MAX96714/MAX96714F/MAX96714R DEV_REV=1 (A-0B) ERRATA SHEET

Corresponds to data sheet 19-101134; Rev2; 05/23

DEV_REV=1 (per reading of register 0x0E)

MAX96714 MAX INSERTION LOSS
GMSL2 CHANNEL PIN-to-PIN (6Gbps)

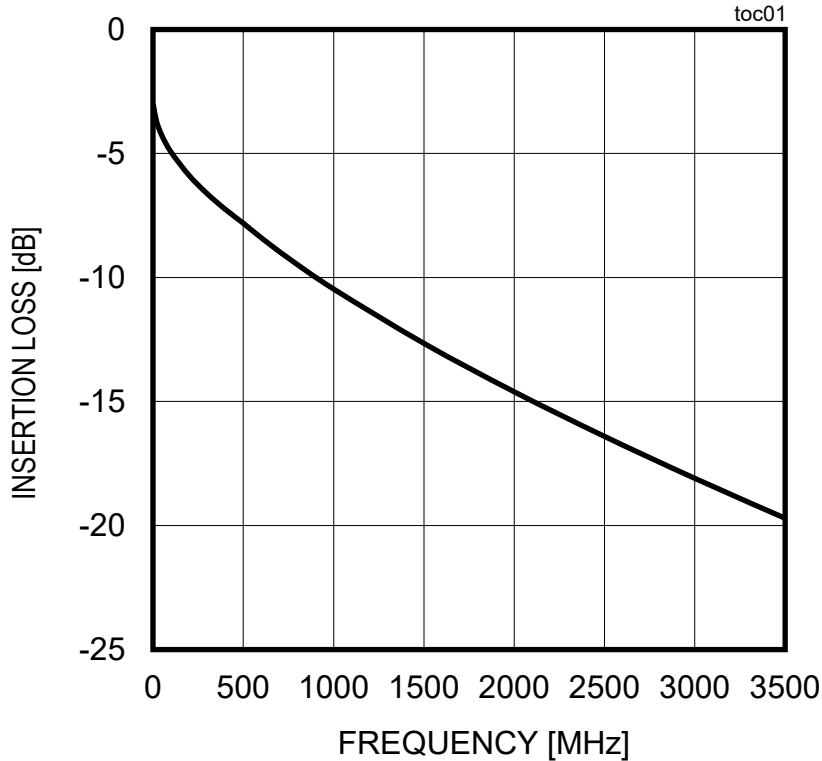
9) Additional information for 6Gbps Insertion Loss Channel Specification (Errata ID = 830005)

The data sheet specifies 6Gbps insertion loss as a single point of -18dB at 3GHz. To fully specify the 6Gbps insertion loss channel specification, the following plot and equations are provided as additional information.

$$IL(f[Hz]) = \begin{cases} -\left(2.74 + 0.21\sqrt{(f \times 10^{-6})} + 0.54 (f \times 10^{-9})\right) & \text{for } 2 \text{ MHz to } 500 \text{ MHz} \\ -\left(2.35 + 0.21\sqrt{(f \times 10^{-6})} + 1.34 (f \times 10^{-9})\right) & \text{for } 500 \text{ MHz to } 3.5 \text{ GHz} \end{cases}$$

Datasheet revision is planned
